Subject: Notification of Class I Permit Modification for the Los Alamos National Laboratory (LANL) Hazardous Waste Facility Permit to Add Structures to a Container Storage Unit, EPA ID # NM0890010515

Class 1 Permit Modification Notification Addition of Structures within Technical Area 54, Area G, Pad 11, Dome 375 Los Alamos National Laboratory Hazardous Waste Facility Permit July 2012

**Class 1 Permit Modification Notification Addition of Structures within
Technical Area 54, Area G, Pad 11, Dome 375
Los Alamos National Laboratory Hazardous Waste Facility Permit**

LAUR-12-22808

Figure 36: TA-54, Area G, Pad 11

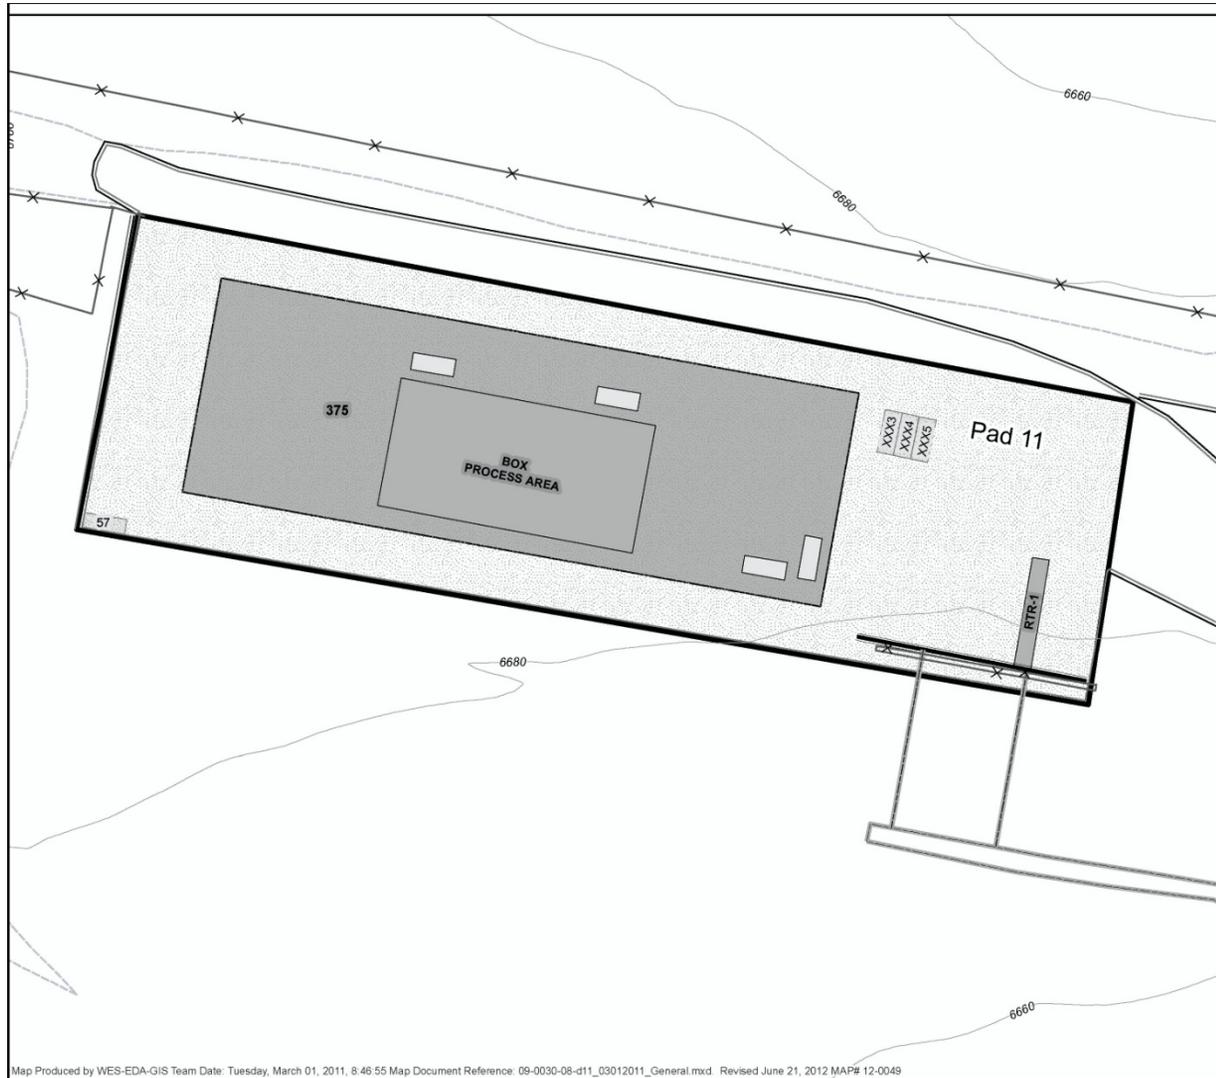
The modification adds structures to the container storage unit at Technical Area (TA) 54 Area G, Pad 11. Structures that will not be used to manage hazardous waste have been added within Dome 375 located at TA-54, Area G, Pad 11.

Descriptions of the structures have been added to Section A.4.2.9 in Attachment A, *TA – Unit Descriptions*; and Section 2.0 in Attachment G.12, *Technical Area 54, Area G, Pad 11 Outdoor Container Storage Unit Closure Plan*. Revised figures are Figure 36 in Attachment N, *Figures*; and Figure G.12-1 in Attachment G.12, *Technical Area 54, Area G, Pad 11, Outdoor Container Storage Unit Closure Plan*.
